ADDENDUM #4: November 15, 2019

FROM: Allied Engineering, Inc.
160 Veranda Street
Portland, Maine 04103
Telephone: (207) 221-2260

RE: Addendum No. **Four (4)** to the Bidding Documents for:
NEW MECHANICS GARAGE LITCHFIELD MAINTENANCE FACILITY MILE
MARKER 92.7

SHEET NUMBER: MH-100

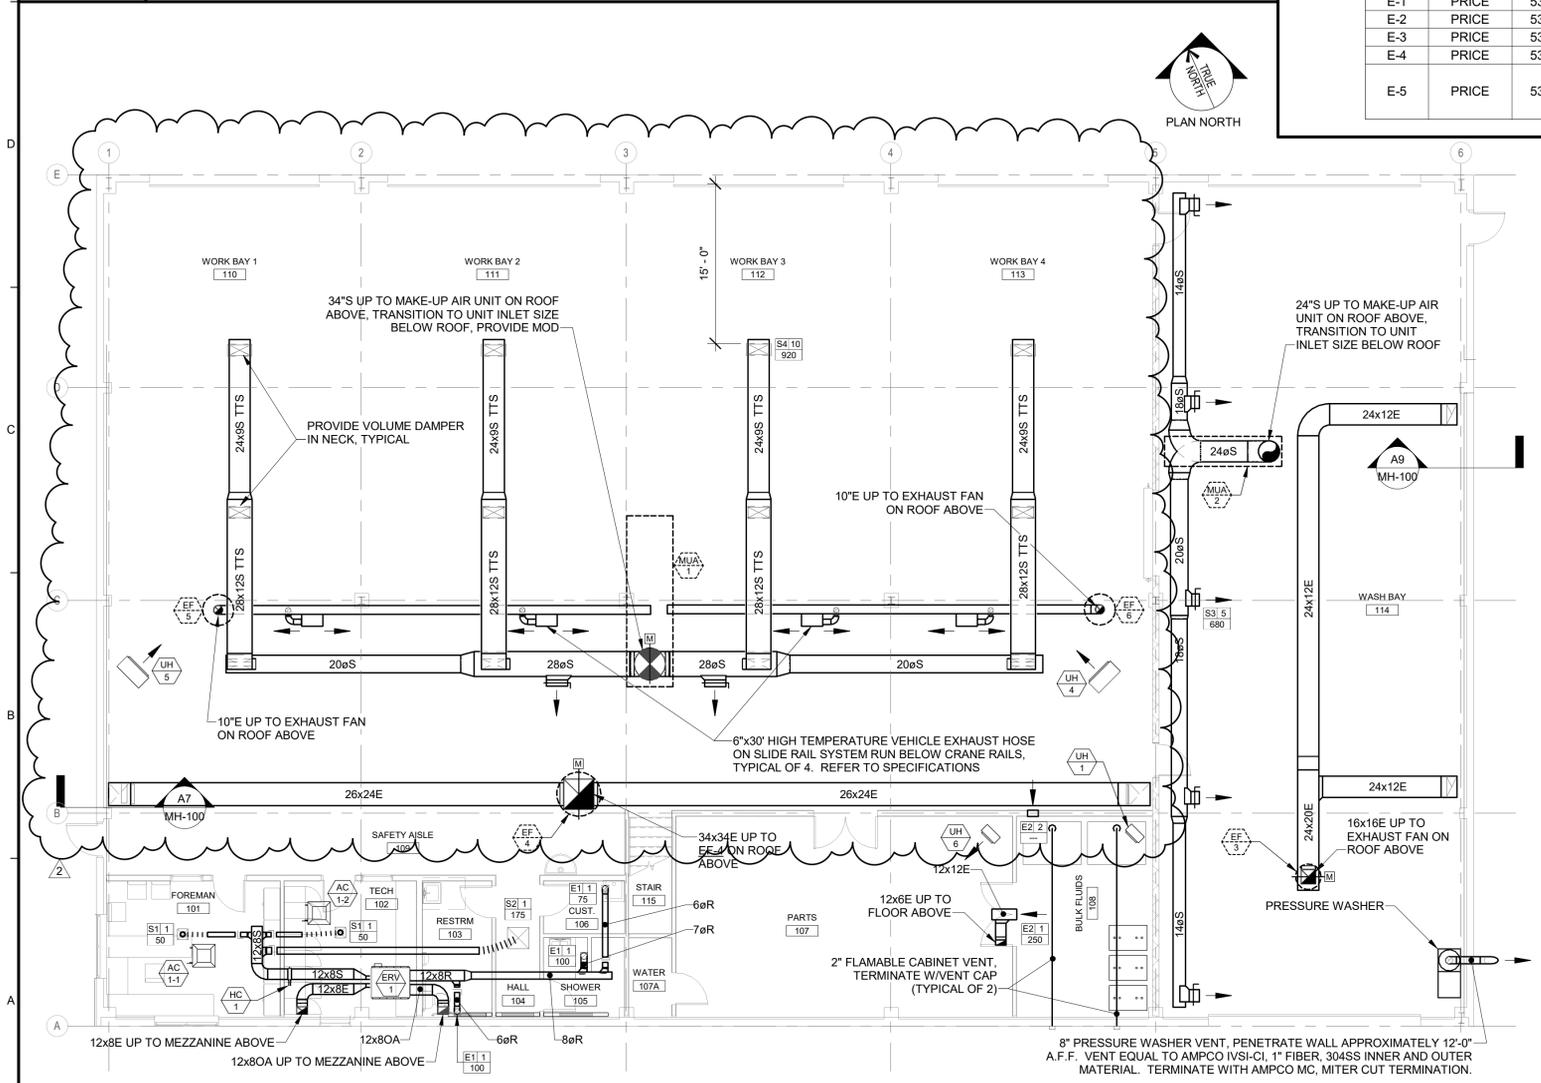
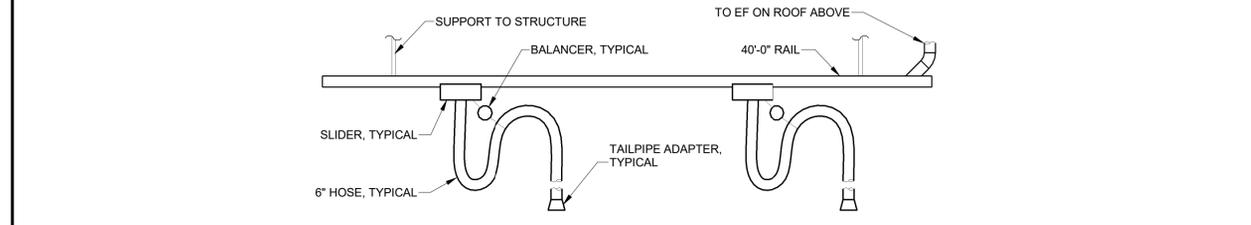
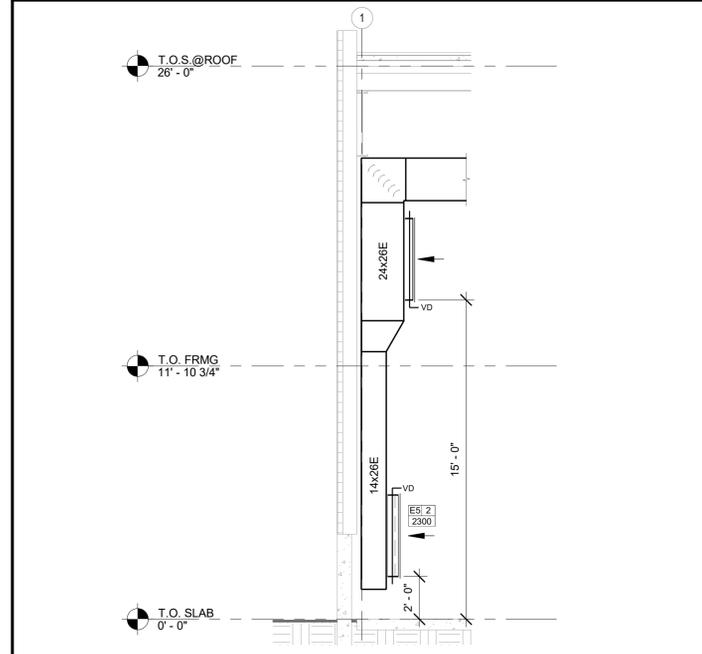
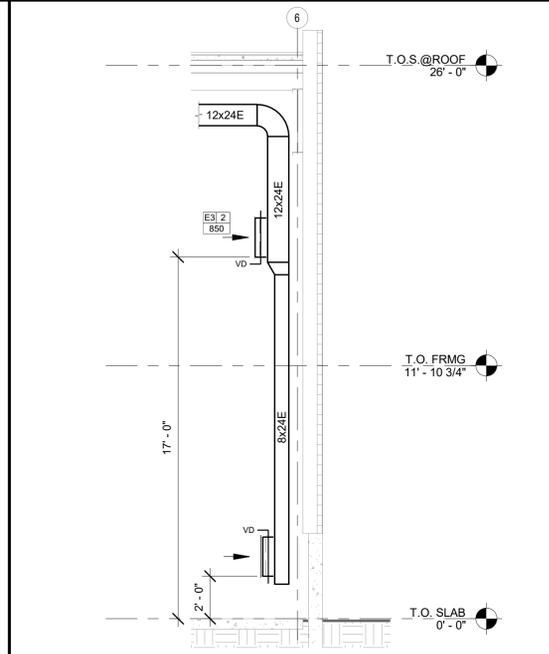
8. DRAWING MH-100 MECHANICAL PLANS: **DELETE** in its entirety and **ADD** in its place the revised sheet attached to this addendum. Drawing MH-100 has been updated for MAU-1 and EF-4 unit and ductwork changes.

SHEET NUMBER: MP-100

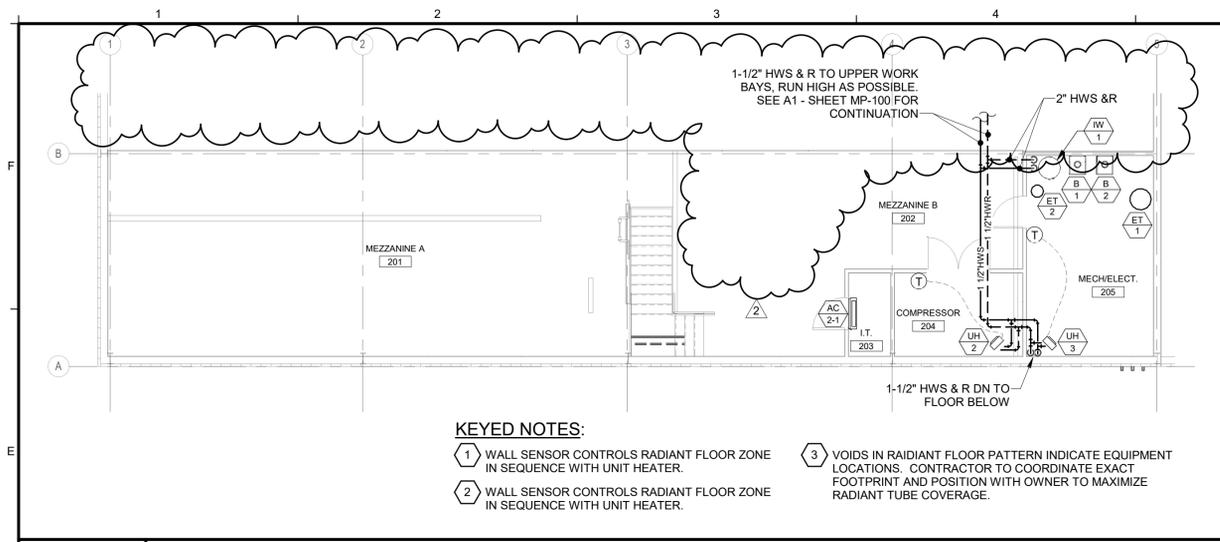
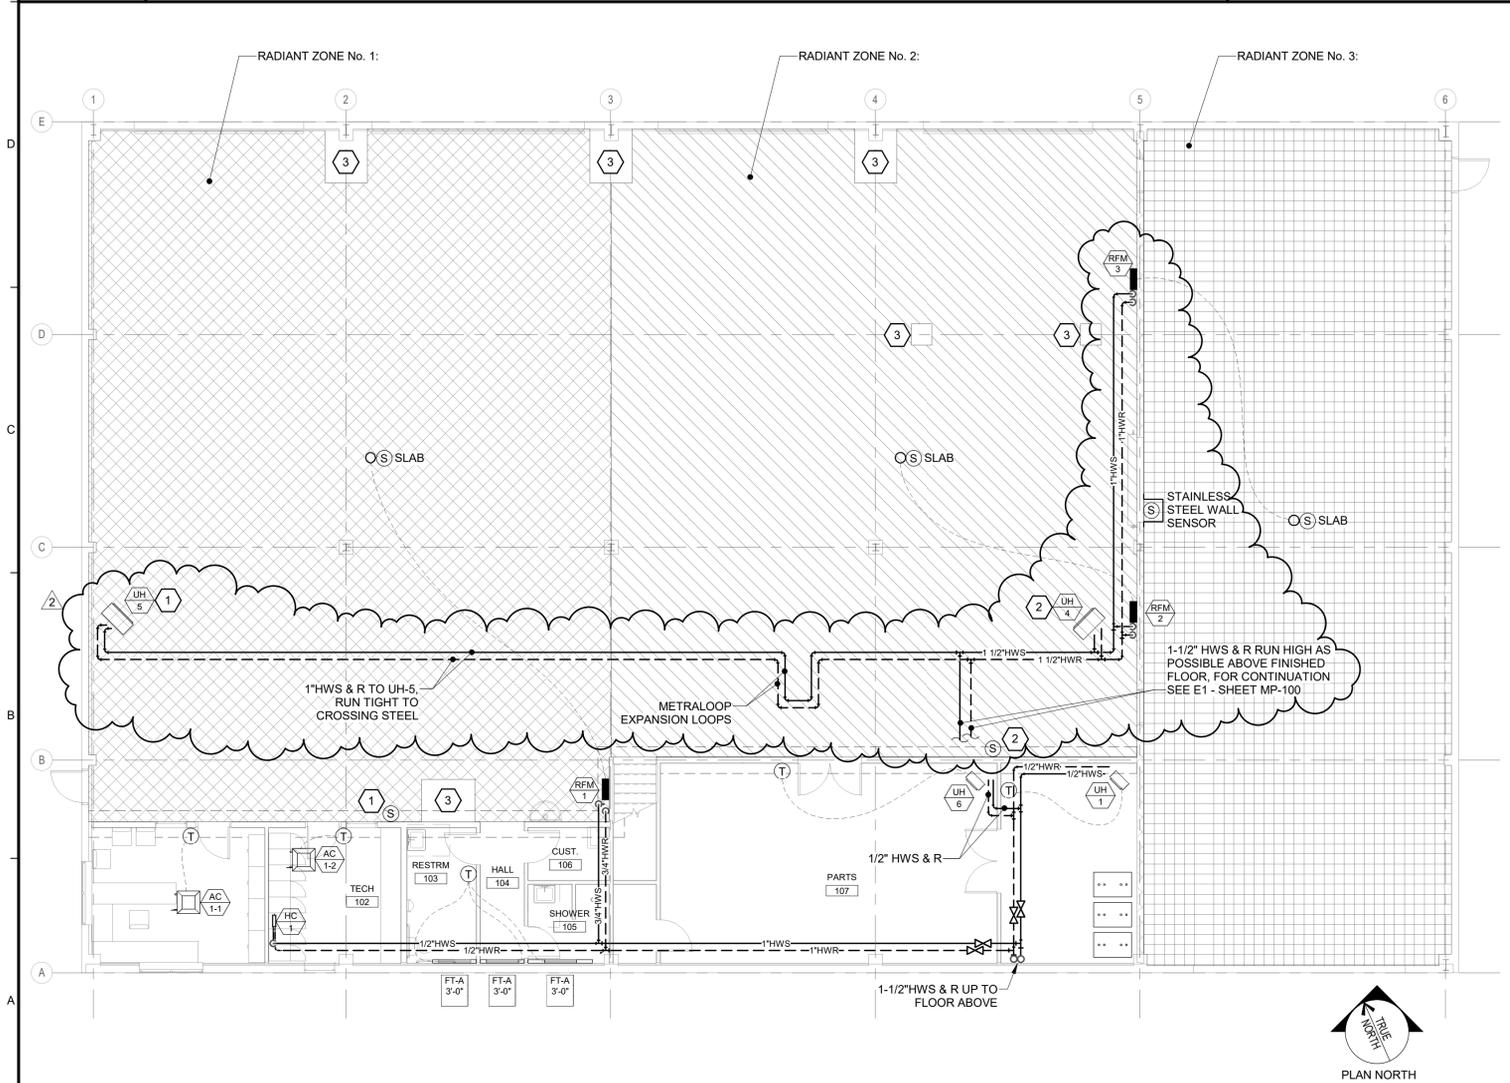
9. DRAWING MP-100 MECHANICAL PLANS: **DELETE** in its entirety and **ADD** in its place the revised sheet attached to this addendum. Drawing MP-100 has been updated to reflect HWS/R piping changes.

SKP-05
 ADDENDUM #4

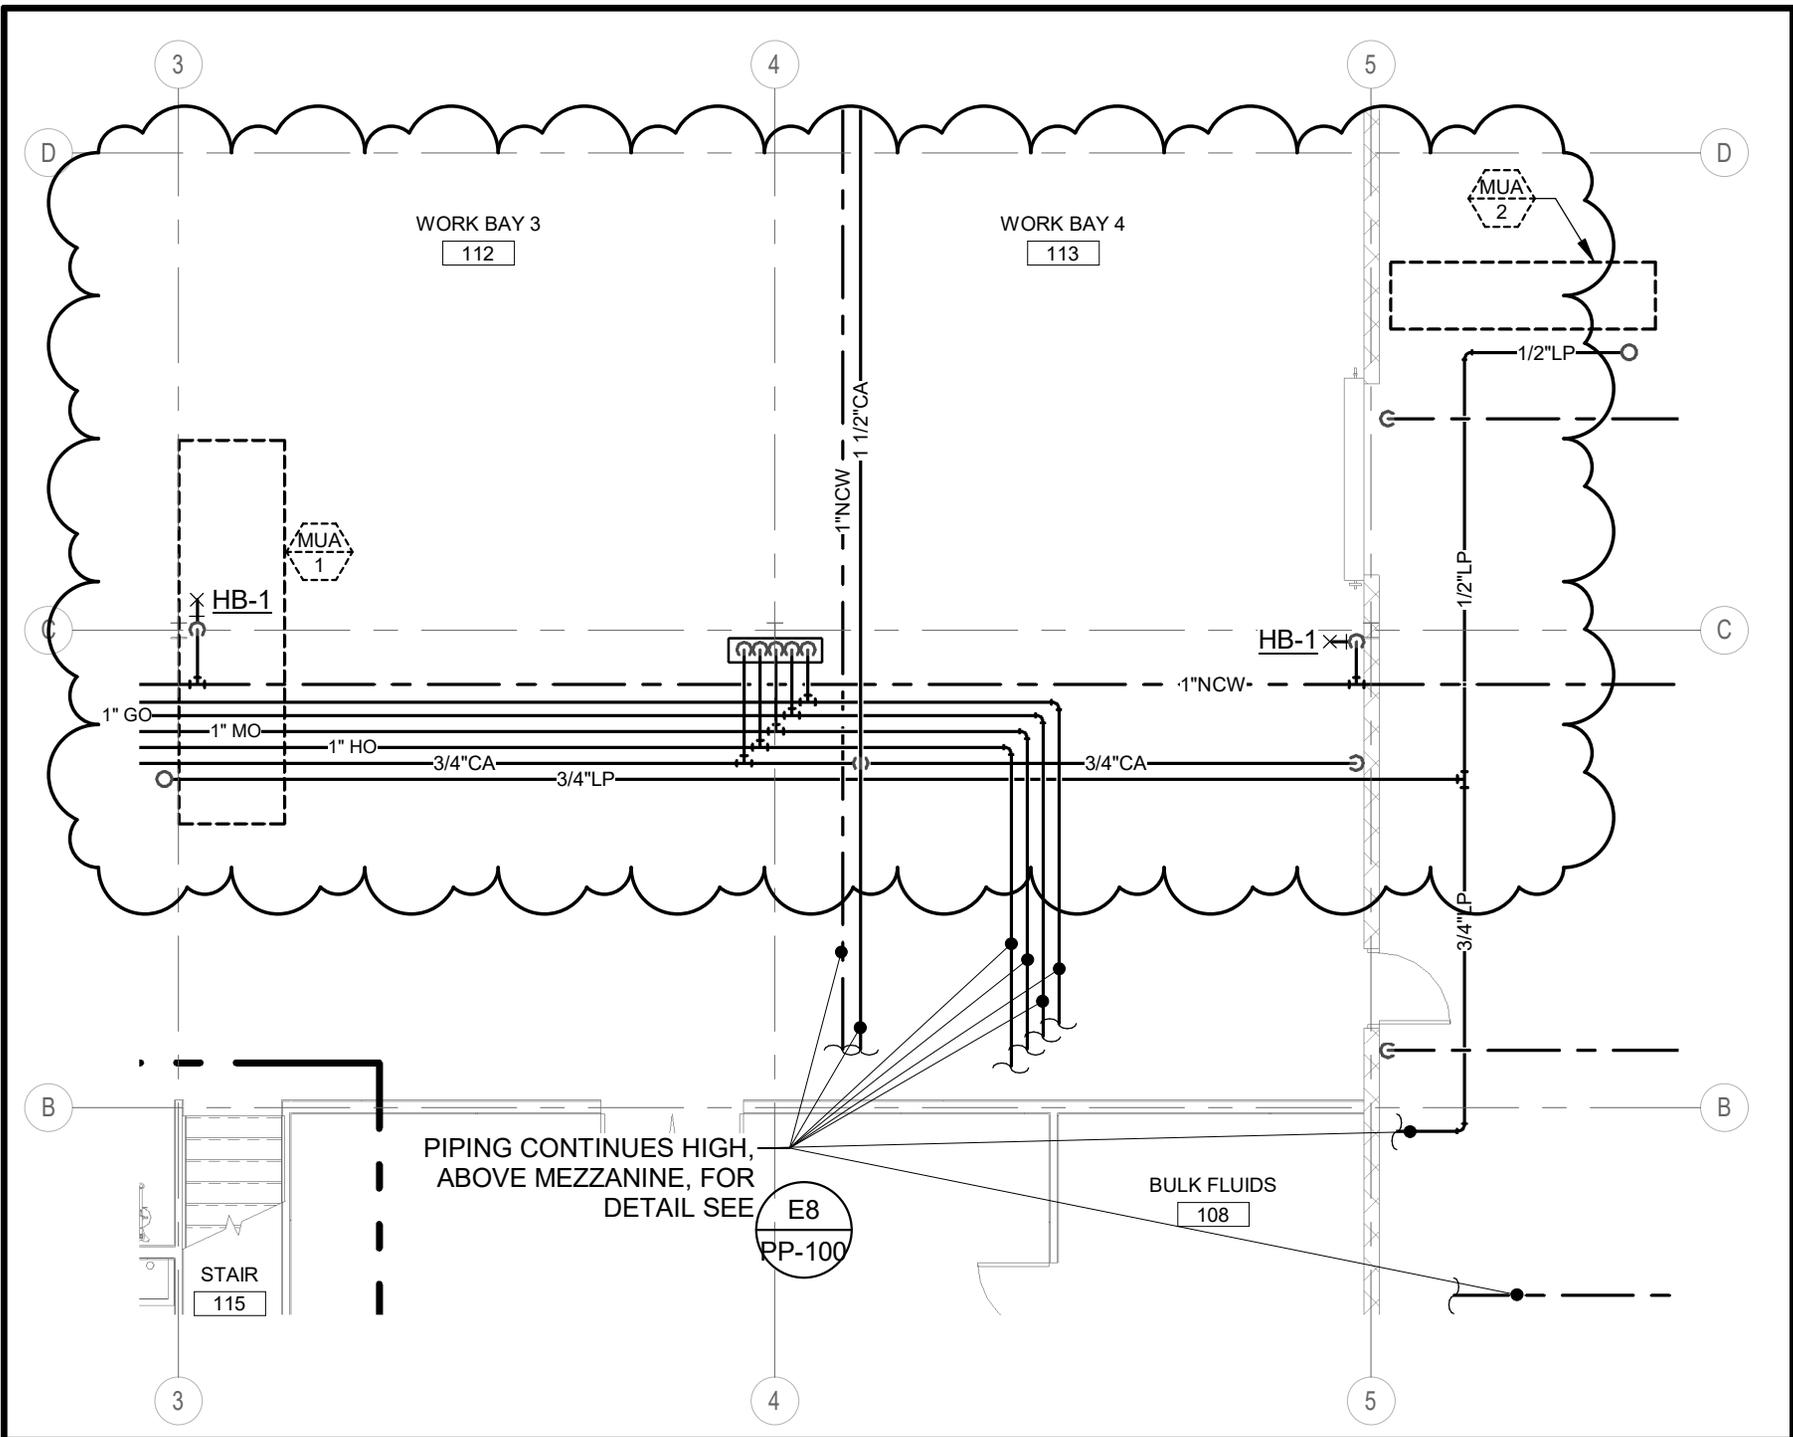
10. DRAWING PP-100 DOMESTIC PIPING PLAN: Refer to Sketch SKP-05: LP gas piping changes associated with MAU-1 relocation.

REVISED MUA-1 GAS PIPING - A1 - SHEET PP-100	
CONTRACT 2019.12, NEW MECHANICS GARAGE LITCHFIELD MAINTENANCE YARD, MILE MARKER 92.7	
Scale: 1/8" = 1'-0"	Project No: 18080
Date: 11/15/19	CAD File:
